e-Callisto Non Conformance Report (NCR)

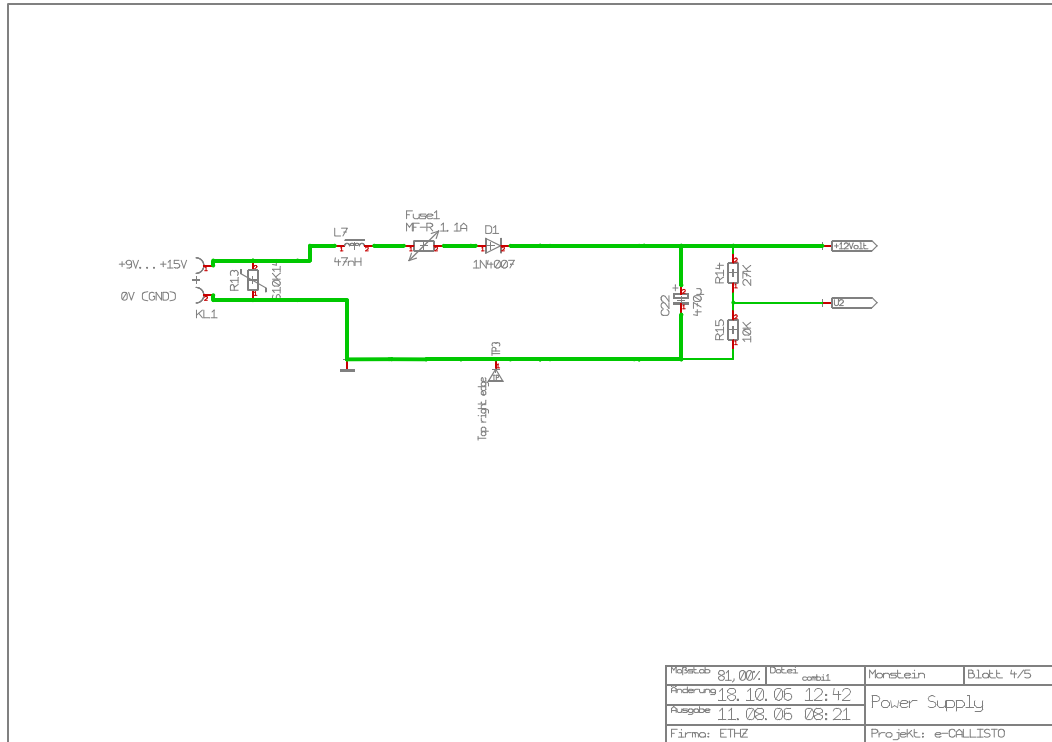
After 10 years of using Callisto it was found out, that the voltage divider R14/R15 to measure supply voltage is wrong designed. The values were correct for a 5V ADC. But years ago it was decided to work with a 2.5C ADC but the voltage divider was never adjusted. Therefore the displayed value during startup of the Application of Callisto is definitely wrong because the ADC is saturated.

During revisions or updates the resistor R14 should be replaced by a 56 Kohm resistor to not saturate the ADC. For a correct display the firmware in ATmega 16 should be updated but, due to the fact that the instruments are distributed all over the world, it is almost impossible to update the software in the chip.

Decision: use hardware and software as it is, no redesign at then moment.
